CITY OF KIRKLAND

MEMORANDUM

Subject: Road Concurrency Appeal for the Potala Village Proposal, File APL11-00007/CON10-00004

POTALA VILLAGE SUBSTANTIAL DEVELOPMENT PERMIT SHR11-00002

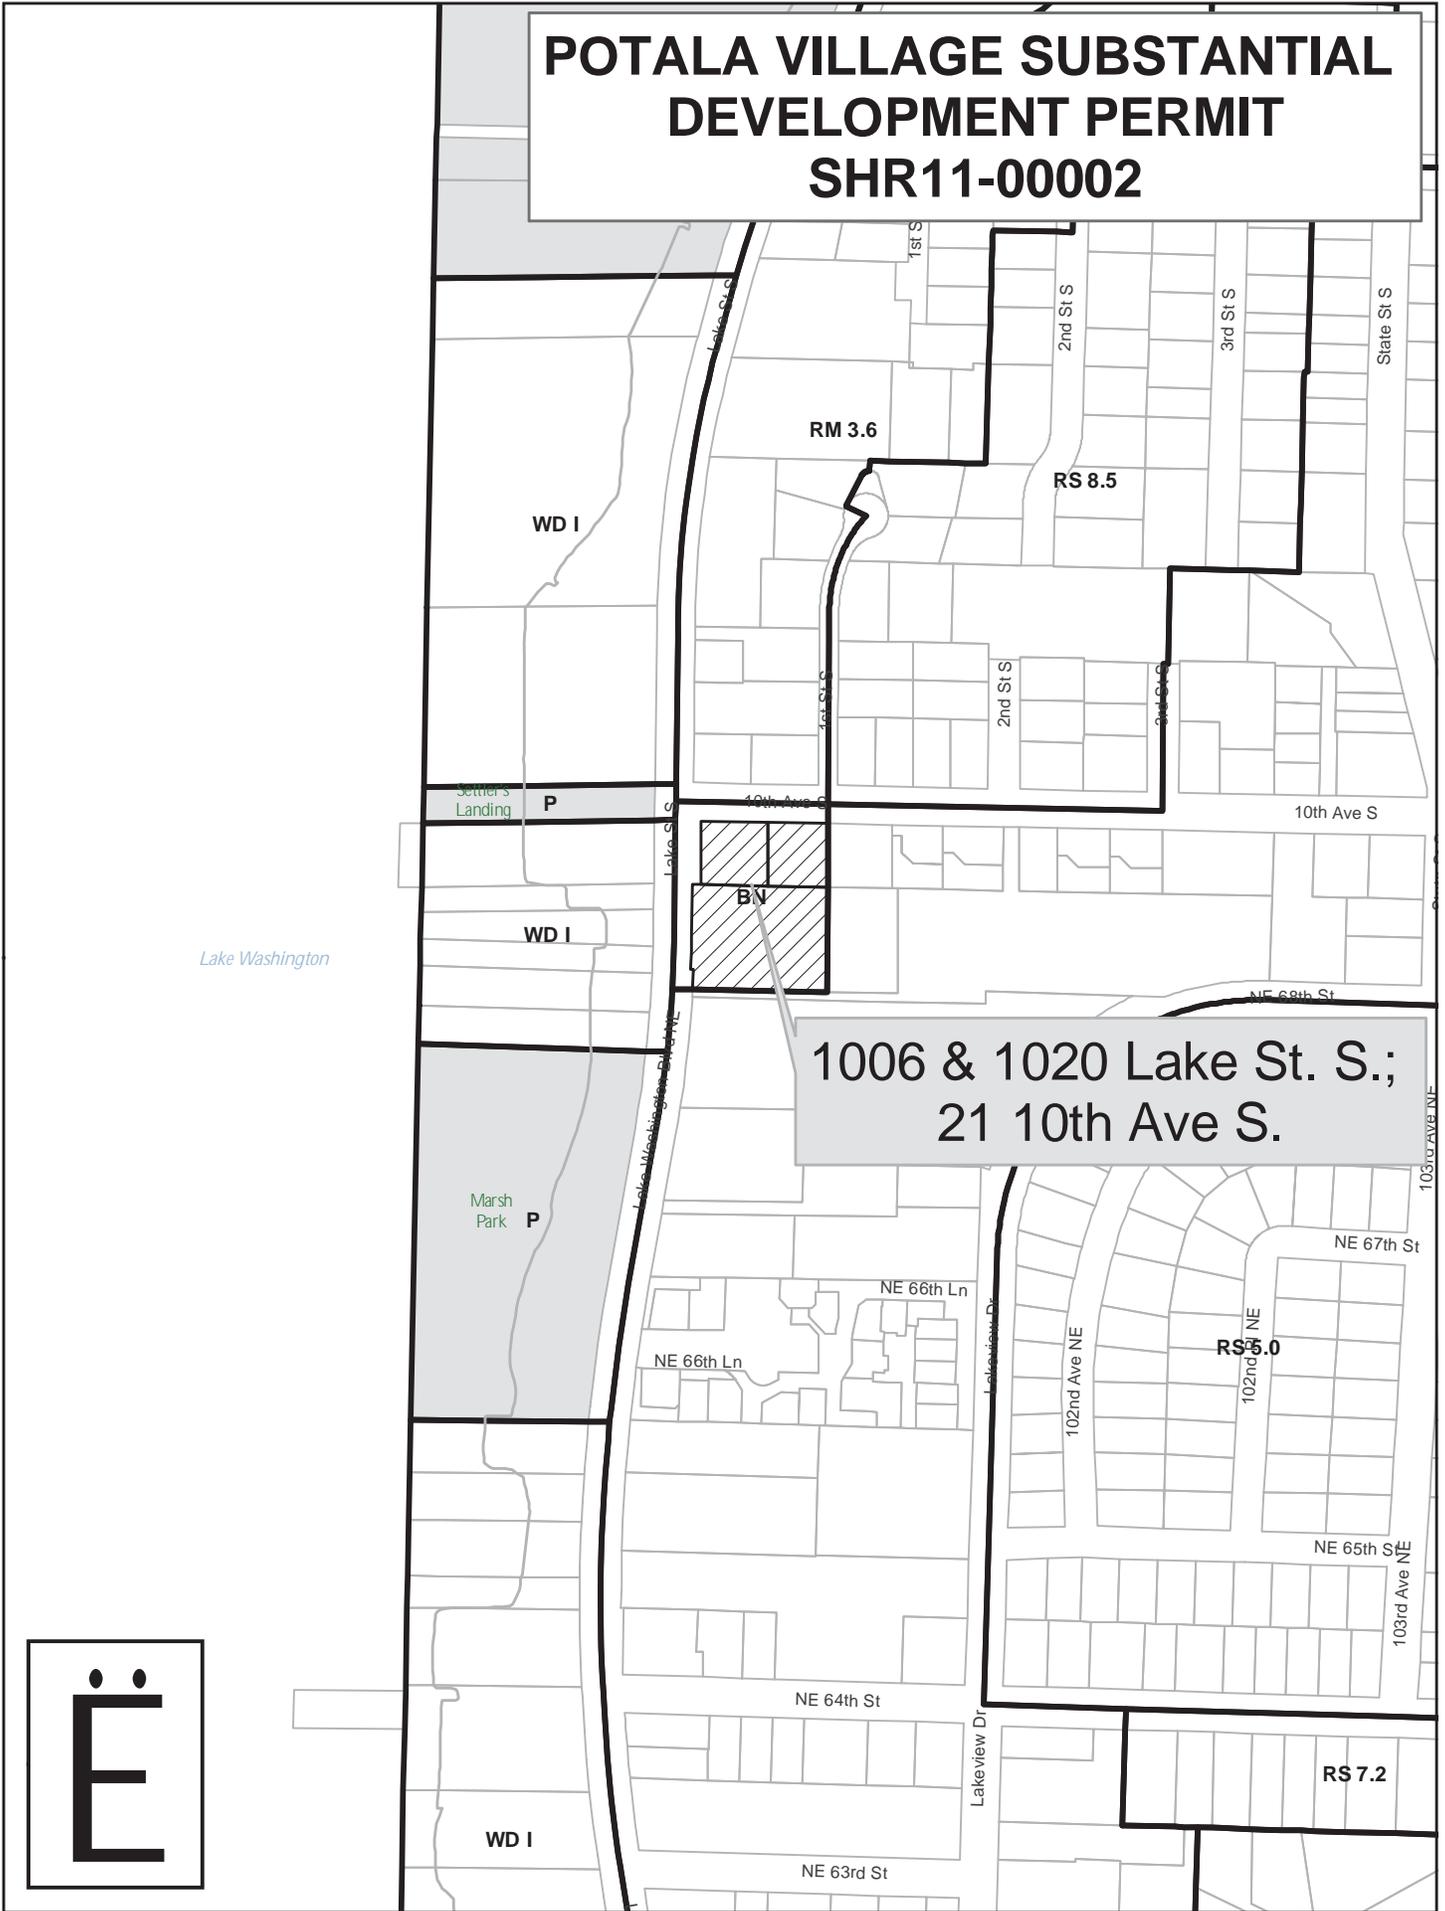
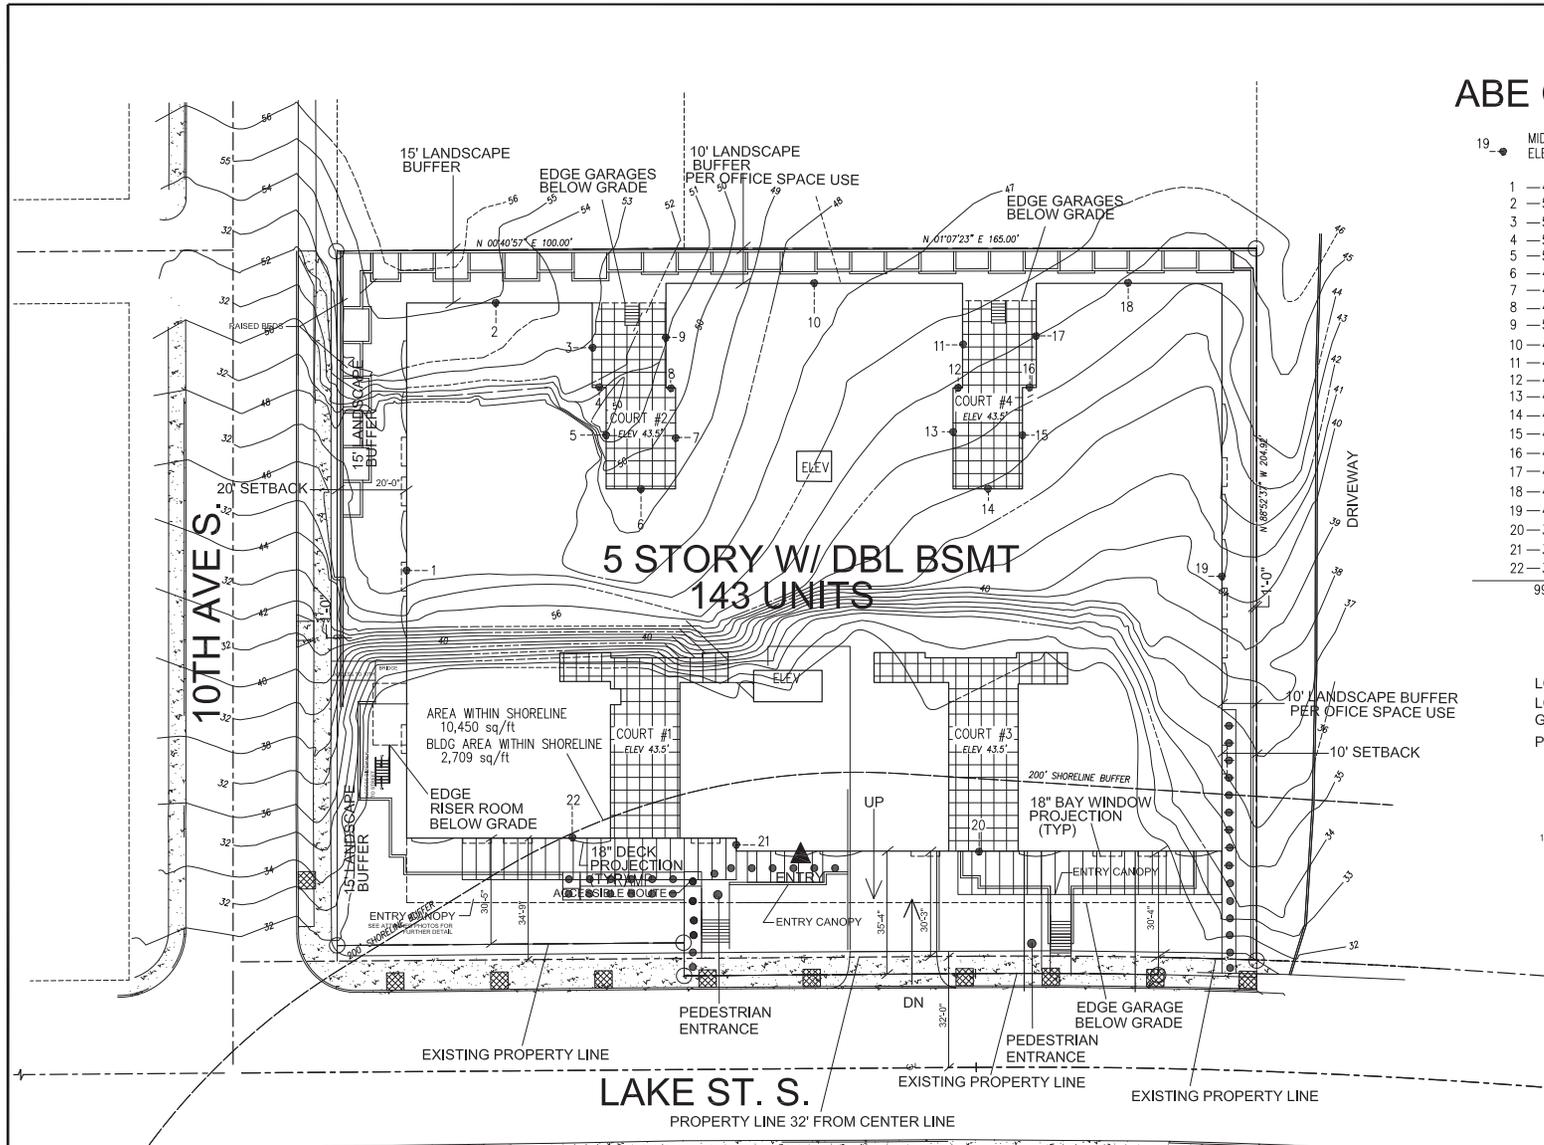
The drawing shows a number on non-compliant parking stalls that do not meet the city's requirement for 8 foot width without obstruction.

Compact parking stalls in the above mentioned drawing marked C6 and C9 are examples of these non-compliant stalls.

Zoning requires that 70% of the first floor be used for retail/office purposes. The plans incorrectly try to use commercial parking against this 70% count. A parking space is not a retail store or office.
